**MITCHELL PARK HORTICULTURAL CONSERVATORY
DOMES
Peer Review**

Final Report

March 14, 2017

National Trust for Historic Preservation

Figure 9. Section through hub from original drawings showing hub cladding drainage system

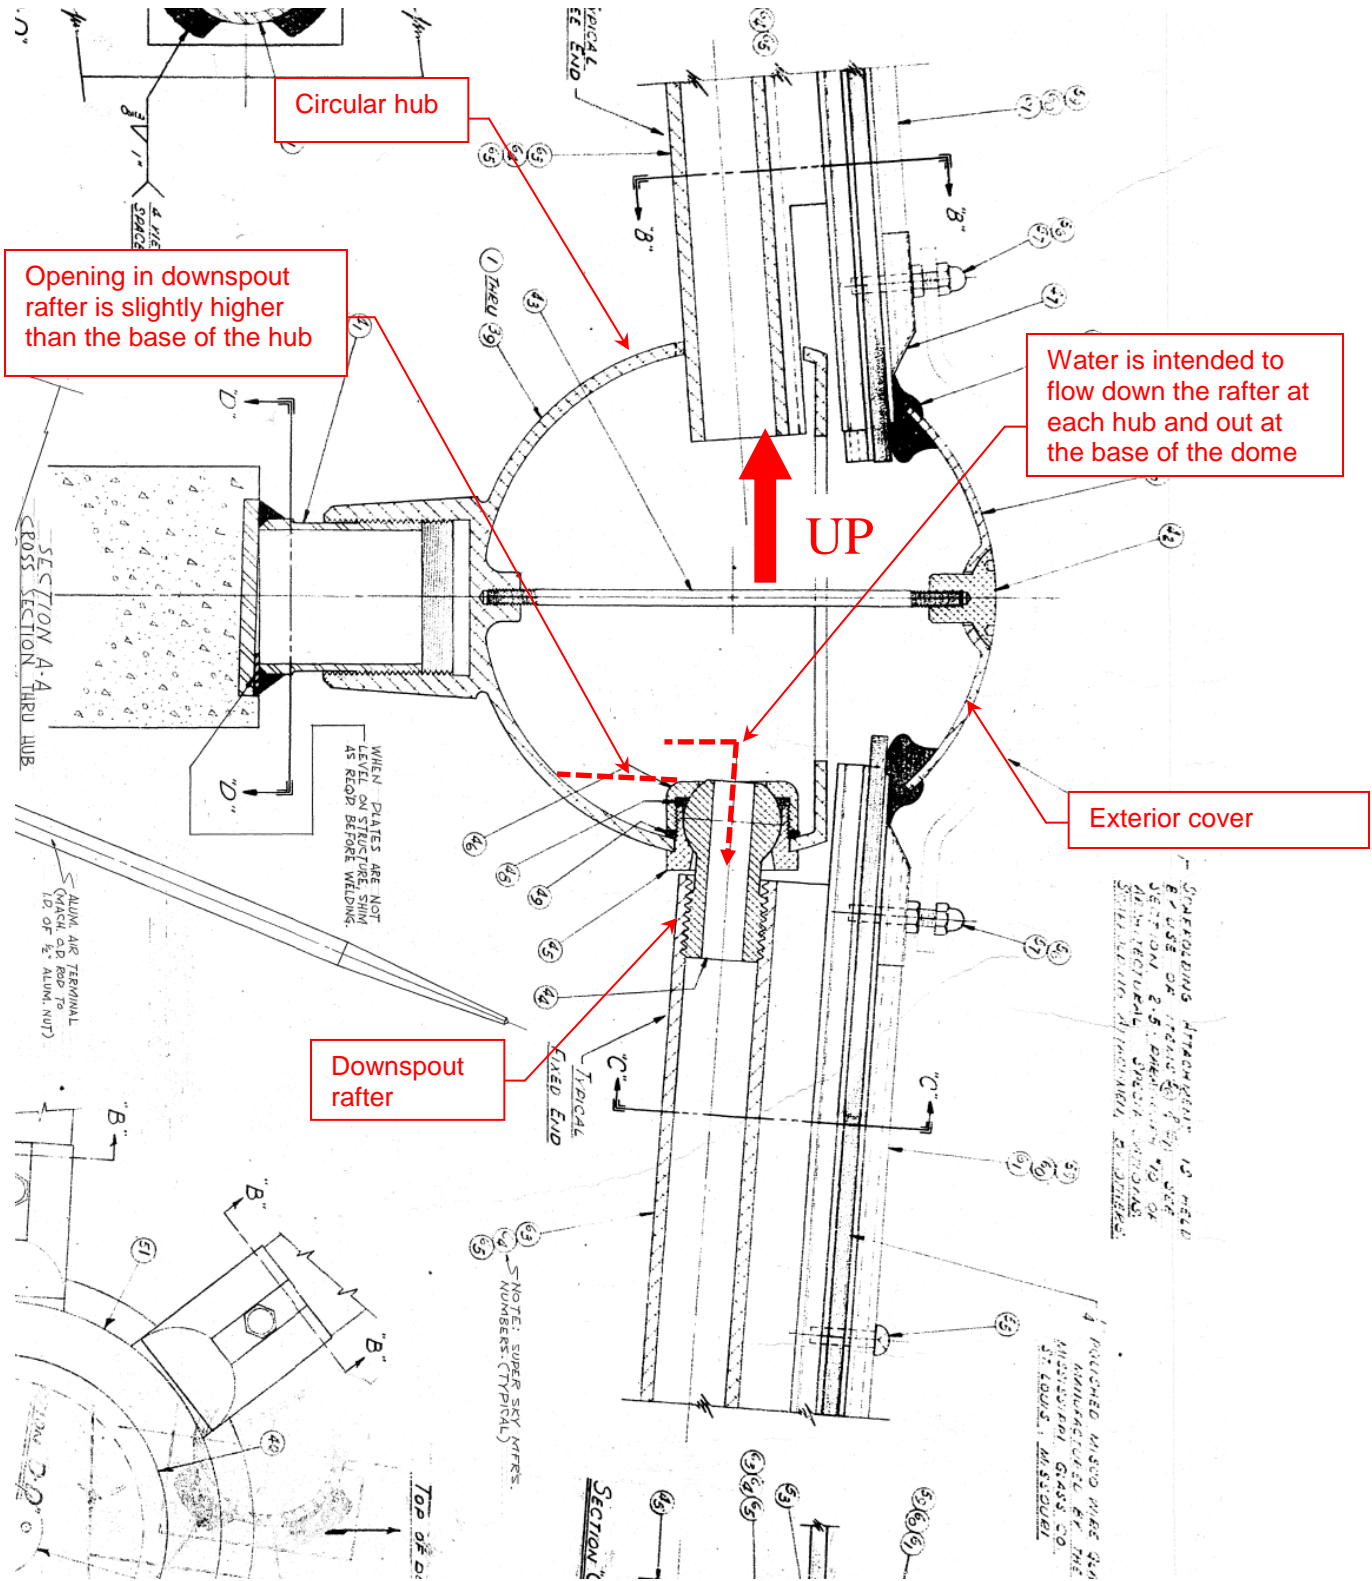
- GRAEF reported that water leakage throughout the domes has historically been a problem and still remains an ongoing issue. GRAEF reported that water was observed sitting in the hub and not allowed to drain. They attribute this problem as due to the fact that the downspout rafter extends higher than the base of the hub (see Figure 9).

Figure 15. Removed spall at connection location. Note: connection is painted with blue colored coating.

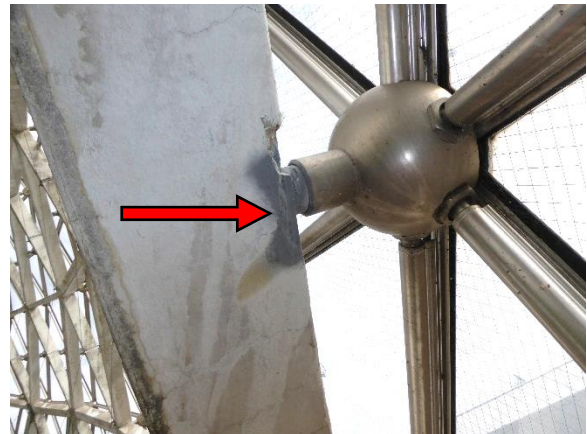
3. Concrete spalls had been removed at several embedded connections where the hub from the glass cladding is supported by the precast framing (Figures 14 and 15). The embedded plate was painted at the location of removed spalls.

Figure 24. Black build-up on downspout rafter fitting at water leakage location

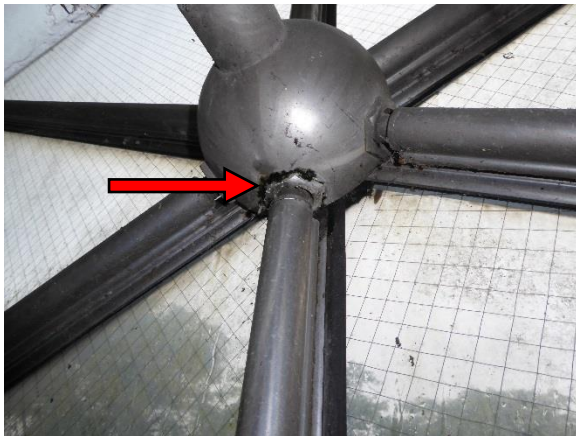
1. Cracked glass units were observed at several locations (Figures 20 and 21). Some of the cracked glass appears to be the result of impact.
2. The glazing material that separates the glass from the pressure caps has deteriorated over time. This is a likely source of water infiltration into the domes (Figure 22).
3. Sealant was installed around the hubs at several locations at the base of the domes (Figure 23).
4. Leakage was observed at approximately six locations in the Arid Dome at the connection of the hub to the downspout rafter. At locations where leaks were observed, the downspout rafter fitting had visible black material build-up, which seems to be an indicator of a leak location (Figure 24).

Figure 25. Section through glass and aluminum frame showing conceptual pressure cap repair for consideration

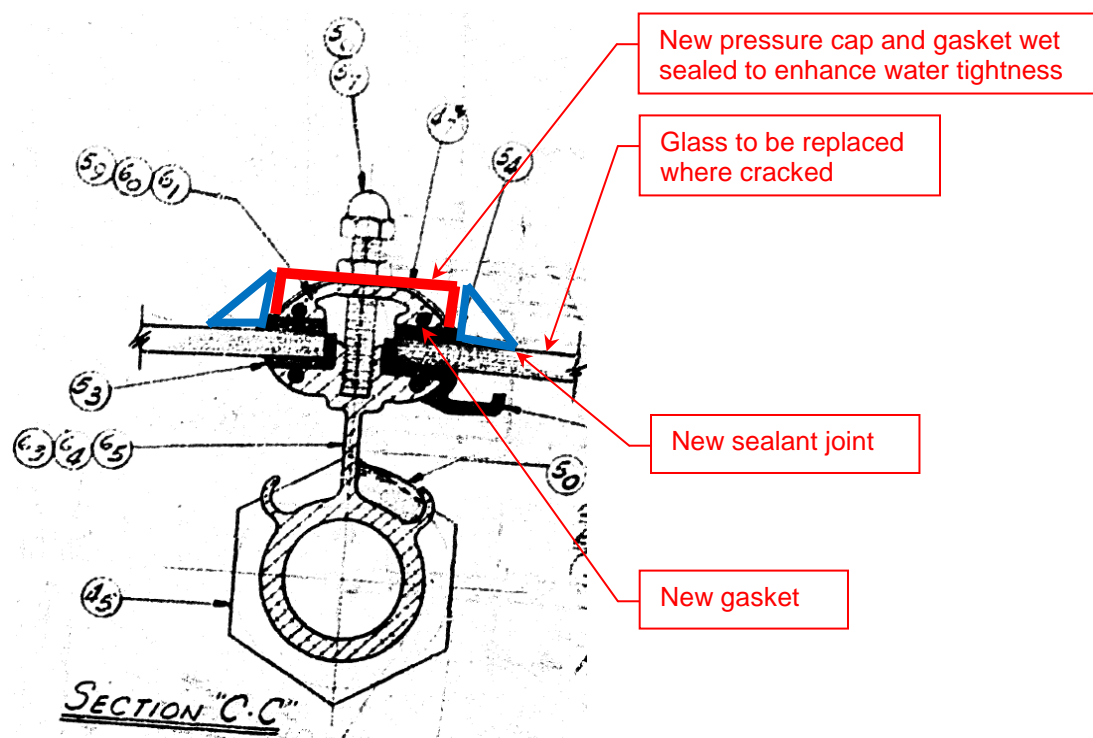
- For weather protection, WJE would normally recommend resealing the glass to aluminum joints around the dome. This is usually performed by a "wet seal" between the glass and the exterior aluminum (the pressure cap). In this case, however, the edges of the existing pressure caps are thin. Obtaining an adequate wet seal joint between the pressure cap and glass would be difficult. As an alternative, removing and replacing the pressure cap with a new redesigned pressure cap would allow for additional weather protection by: a) replacing the exterior glazing seals between the glass and the pressure cap with new glazing seals, and b) a thicker edge detail on the new pressure cap, which would allow a wet seal to supplement the new glazing seal. We believe that this redesign would largely resolve rain water leakage through the dome. We believe that this is a practical step for GRAEF to consider as an addition to their Option 1 repair.

1. Replace existing cracked and broken wired glass in kind, or with laminated glass. Modifications in the glass replacement design could be implemented based on the findings from further investigation and mock-up repairs.
2. Remove and replace all pressure caps and wet seal joints (Figure 25).
3. Clean hubs and install self-leveling sealant at leading hubs (Figure 26).
